KANEOHE BAY DRIVE REALIGNMENT

CULVERT DETAIL

Sheet 4 of 8 sheets

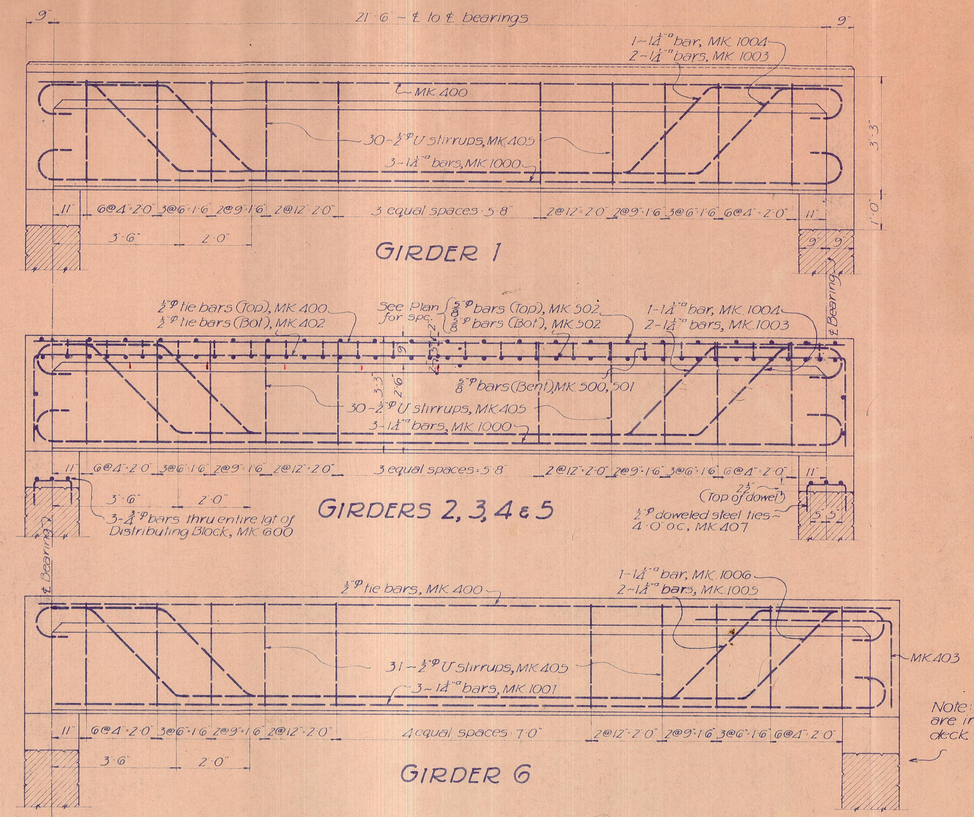
Note: Girders 6 & 7 are correct in detail but are in error in regards to curvature of deck. Construct opposite hand to that shown. (See Plan for curvature of deck)
